**DOCKET NUMBER 50-483  
UNION ELECTRIC COMPANY  
CALLAWAY PLANT  
RESPONSE TO REQUEST FOR ADDITIONAL INFORMATION  
REGARDING REQUESTS FOR RELIEF FROM  
ASME SECTION XI CODE INSERVICE EXAMINATION REQUIREMENTS  
(ISI-24, ISI-25 AND ISI-26)**

RESPONSE TO REQUEST FOR ADDITIONAL INFORMATION

RELIEF REQUEST NOS. ISI-24, ISI-25, AND ISI-26

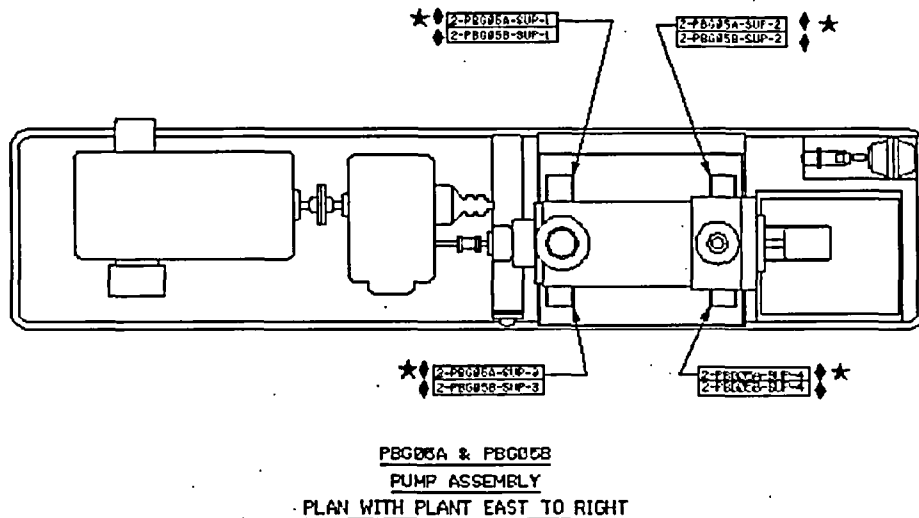
3. (1) Provide drawings and/or diagrams of weld nos. 2-PBG05A-SUP-3 and 2-PBG05A-SUP-4. The diagrams should include weld dimensions and material, and pipe support components that impede or obstruct the examination. (2) Discuss how 69 percent of surface coverage was determined for weld 2-PBG05A-SUP-04, and how 31 percent of the weld surface could not be examined. (3) Discuss the surface examination method (e.g., liquid penetrant or magnetic particle).

5. (1) For weld 2-PBG05A-SUP-4, discuss whether a best effort examination and/or other inspection methods have been considered to increase the surface examination coverage of the remaining 31 percent weld surface area that has never been examined. (2) Discuss whether the SUP-3 weld and SUP-4 weld are for the same pump and whether both welds need to be examined during the upcoming outage. Based on the staff's understanding of Table IWC-2500-1, all support welds in one pump should be inspected. (3) Discuss how many support welds are in both charging pumps (A and B), how many pump support welds are included in the second 10-year inspection interval, and the inspection schedule for each of the pump support welds in the inservice inspection program. (4) Discuss why inspection of the SUP-3 weld could achieve 100 percent surface examination whereas inspection of the SUP-4 weld could only achieve 69 percent surface examination if they are for the same pump.

The figure above is a detail from the ISI drawing of PBG05A and PBG05B showing the location of SUP-3 and SUP-4 [Q3(1), Q5(2),(3)]. Note that SUP-4 is located on the discharge end of the

*"A" Centrifugal Charging Pump (CCP) which has a larger diameter than the inlet where SUP-3 is located. This larger diameter is the cause of the obstruction as is shown on the following four images.*

DATASHEET No. 6216-02-013 Component Identification 2-AE-04-F043

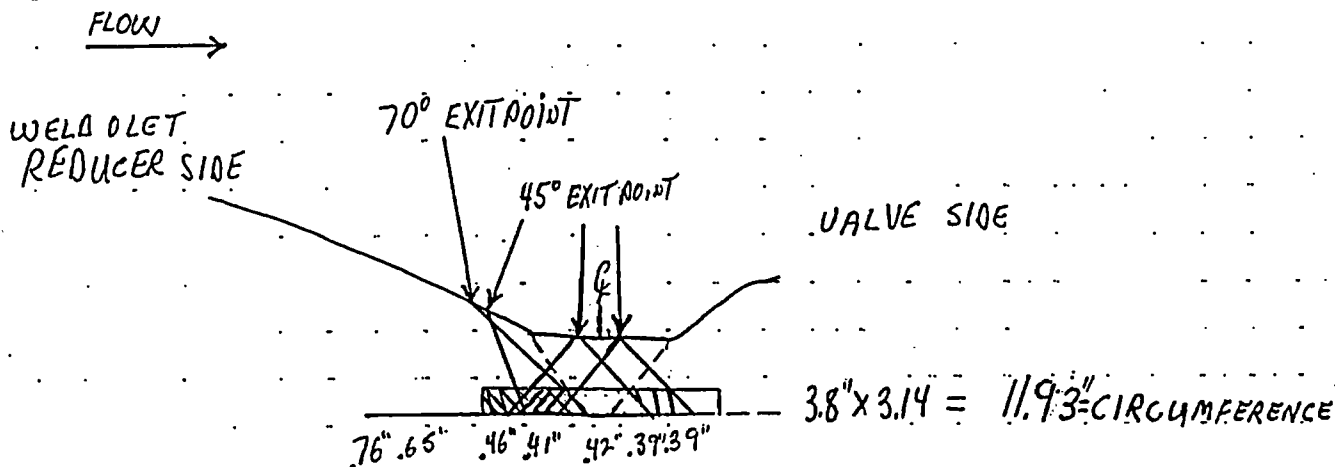
6. For Section 4.B of ISI-24 and ISI-25: (1) Provide diagrams and/or drawings showing the 2-AE-04-F043 weld configuration and associated weldolet, valve, and pipe. (2) Show how pipe and valve components obstruct the examination. (3) Demonstrate how 67 percent volume coverage was determined. (4) Show the transducer travel paths, directions, and scan angles on the diagrams and/or drawings. (5) Provide information on the weld material. (6) Discuss whether a surface examination is required by the ASME Code, Section XI. (7) Clarify whether the required inspection is based on Table IWC-2500-1. (8) Clarify where in Table IWC-2500-1 can Item number "NBZ EXAMS-1" be found. (9) Discuss why Appendix VIII to the ASME Code, Section XI, 1995 edition, is not used, or referenced, for the ultrasonic examination of weld 2-AE-04-F043.

7. In Section 6.B of ISI-24 and ISI-25, it is stated that, based on no indications being detected in weld 2-AE-04-F043, the weld integrity has been assured. This statement is true only for the 67 percent of the weld volume that was inspected. It appears that the remaining 33 percent of the weld volume has not (or never) been inspected. Based on this, discuss whether a best effort examination has been considered to increase the examination coverage. Also, discuss how many times this weld has been inspected and whether other inspection methods could be applied to the remaining 33 percent of the weld to assure its structural integrity.

*The ISI Data Review sheet (and attendant pages) for 2-AE-04-F043, including the calculation of coverage, is enclosed [Q6(1-4)]. (See pages 9 through 14.) The weld material is carbon steel [Q6(5)].*

For the most recent examination, a best effort examination was performed. All available techniques were used, including the use of a 70° and 45° axial scan to achieve the most coverage possible. Only qualified techniques were recognized for the coverage calculation. Please see the enclosed sketch (page 14) for configuration and coverage [Q7].

$$= \frac{267.98}{4} = 67.0\%$$

NOTE: For Austenitic welds, no coverage may be claimed on the inaccessible side of single sided exams. Coverage claimed may not exceed 50%.

EXAM AREA =  $0.14 \times 1.2 = 0.17$  TOTAL  $0.17 \times 11.93 = 2.03$   
 SHEAR  $45^\circ$  US INCOMPLETE 0.75" TOTAL AS INCOMPLETE 0.95"  
 SHEAR  $70^\circ$  US SUPPLEMENTAL = 0.10" COMPLETE  
 SHEAR  $45^\circ$  0.75 INCOMPLETE MINUS SHEAR  $70^\circ$  0.10" COMPLETE = 0.65" INCOMPLETE US SIDE
